**Conservation Law Foundation • Earthjustice • Environmental Integrity Project •  
Sierra Club**

**RE: Response to Statement of Substantial New Questions for Public Comment,  
Merrimack Station, NPDES Permit No. NH0001465**

**Figure 1: Merrimack Quarterly Heat Input, 1995-Present<sup>21</sup>**

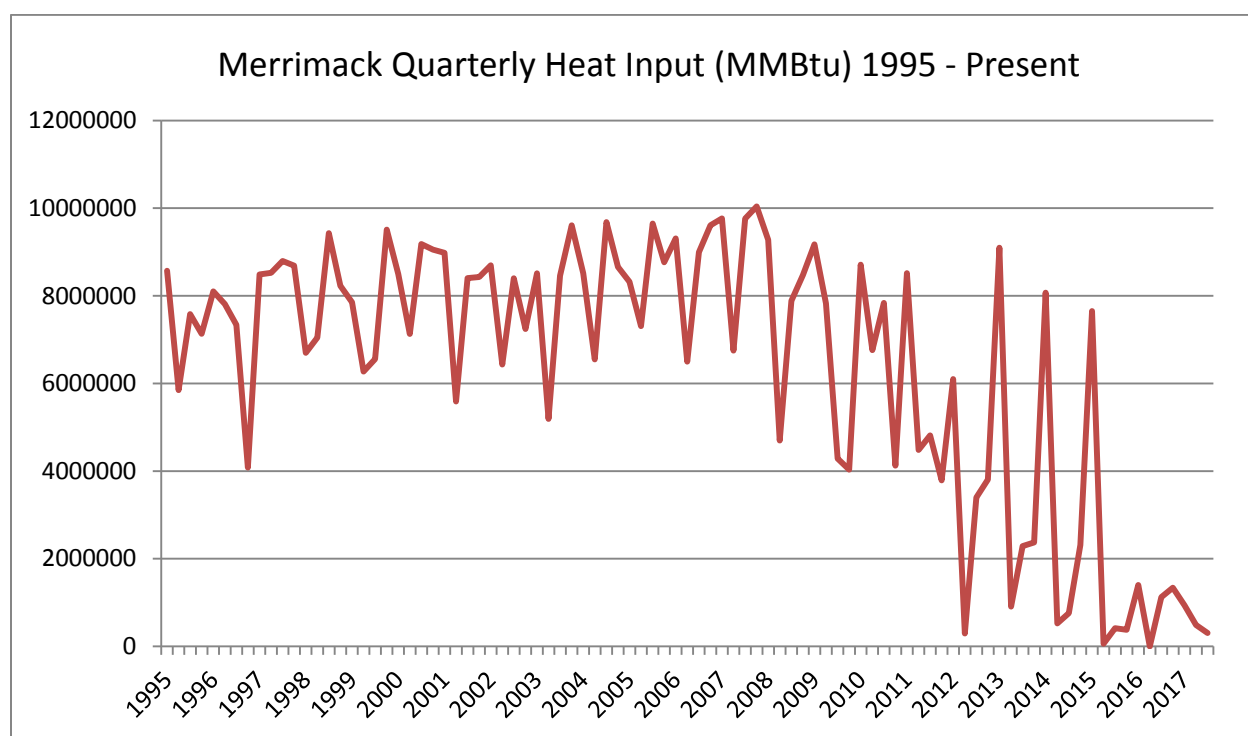
Third, the unfortunate fact is that EPA is extremely slow in issuing NPDES permits for large facilities in New Hampshire, and for Merrimack in particular. These comments are submitted as part of the third round of comments solicited by EPA on this one permit, in a process that started over five years ago. Indeed, Merrimack has been operating under a permit that expired two decades ago, and was issued a *quarter-century* ago. Although Commenters certainly hope that EPA will finalize this permit soon, and will thereafter hew to the five-year permit review cycle mandated by Congress, the history of this permit and this plant raises the possibility that whatever permit EPA does finalize for Merrimack may govern the plant's operation for many years to come. Just as Merrimack's operation has changed considerably in the past, it is possible that it will vary considerably in the future.

As such, it would be both irresponsible and contrary to law for EPA to set NPDES permit limits for Merrimack based on an assumption that, because the facility currently operates at a relatively low capacity utilization, certain wastestreams and pollution levels are unlikely to be relatively high in the future and therefore need not be limited.
